RAI Volume 4, Chapter 2.5.3.2, First Set, Number 1: The following questions are related to Title 10 of the Code of Federal Regulations (10 CFR) Part 63, specifically, 10 CFR 63.21(c)(22).

The DOE will revise Figure 5.3-1 as shown below.

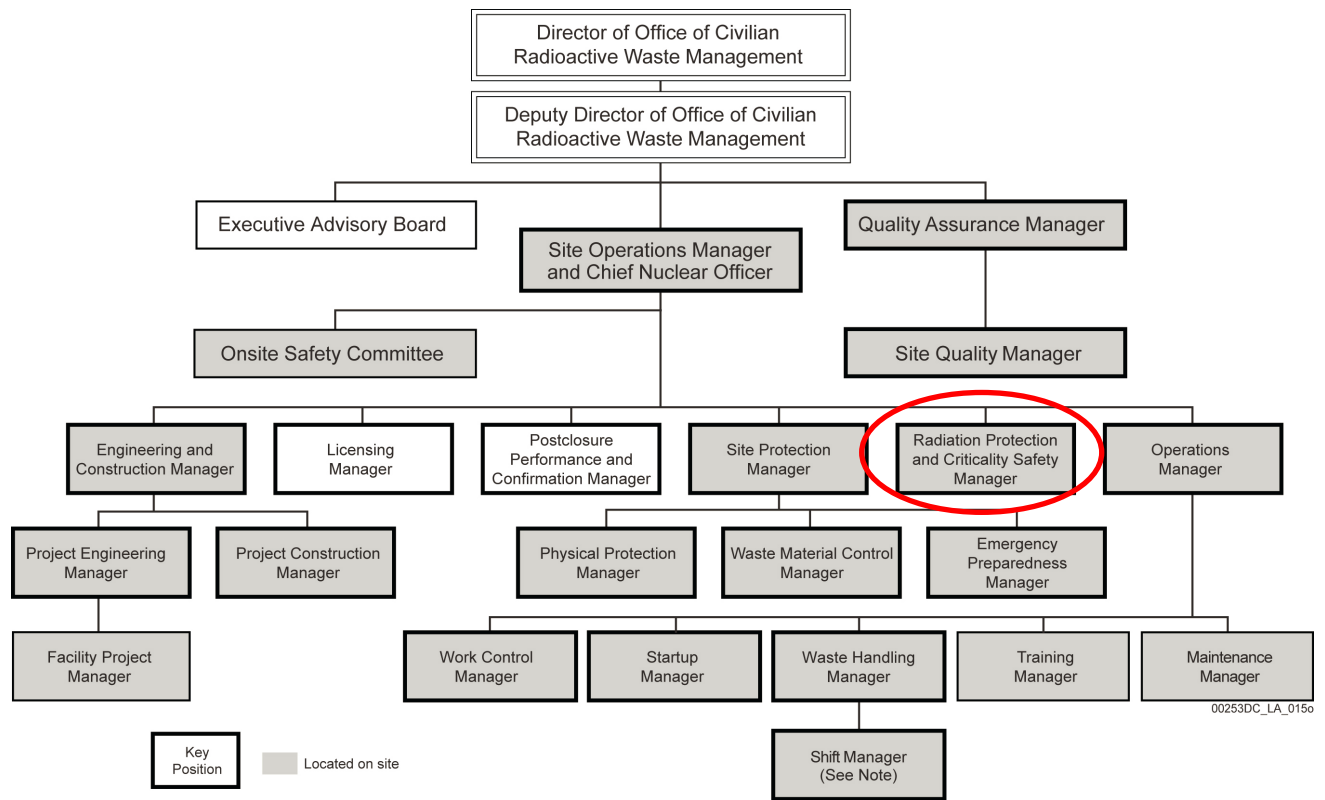
Explain how the organizational assignment of the Nuclear Criticality Safety Program (NCSP), as given in the proposed organizational chart (SAR Figure 5.3-1), is consistent with DOE's commitment to ANSI/ANS-8.19-2005, American National Standard, Administrative Practices for Nuclear Criticality Safety (as referenced in SAR Section 1.14.1). Specifically, explain how the NCSP is administratively independent of operations, and how the NCSP organizational functions and responsibilities are assigned in a manner consistent with those of other safety programs (such as Radiation Protection).

Alternatively, provide a revised organizational chart and explain the NCSP's organizational assignment, functions, and responsibilities, consistent with ANSI/ANS-8.19-2005.

The U.S. Department of Energy (DOE) has reviewed the organizational structure as shown in SAR Figure 5.3-1 and has decided that the proposed organization should be revised to improve the administrative independence of the Nuclear Criticality Safety Program (NCSP) from operations. The revised organizational structure will combine the Criticality Safety Manager functions with those of the Radiation Protection Manager and will be called the Radiation Protection and Criticality Safety Manager. This change will allow the NCSP to be administratively independent of operations and to function organizationally and to have responsibilities assigned in a manner consistent with those of other safety programs (such as Radiation Protection).

The Radiation Protection and Criticality Safety Manager will be at an equivalent level to the Operations Manager. Both managers will report to the Site Operations Manager and Chief Nuclear Officer. Reporting to the Radiation Protection and Criticality Safety Manager will be a Senior Nuclear Criticality Safety Specialist and a Senior Radiation Protection Specialist. Both specialist positions will require as a minimum, a bachelors degree in engineering, the physical sciences, or have equivalent technical experience. In addition, the Senior Nuclear Criticality Safety Specialist will have at least three years of nuclear industry experience in criticality safety. The Senior Radiation Protection Specialist will have at least three years of nuclear industry experience in radiation protection.

These organizational changes require revision to SAR Figure 5.3-1 and several SAR sections which currently describe the radiation protection and the nuclear criticality safety functions separately. The revisions to the organizational assignment, functions, and responsibilities, shown in Section 3 of this response are consistent with ANSI/ANS-8.19-2005 and the DOE commitment to the standard since they provide the NCSP with:

The DOE commits to revise the LA to reflect the change to SAR Figure 5.3-1 and associated text indicating the organizational structure shown in the attached figure. SAR Figure 5.3-1 and the text in SAR sections which describe the radiation protection and the nuclear criticality safety functions will be revised in a future LA update.
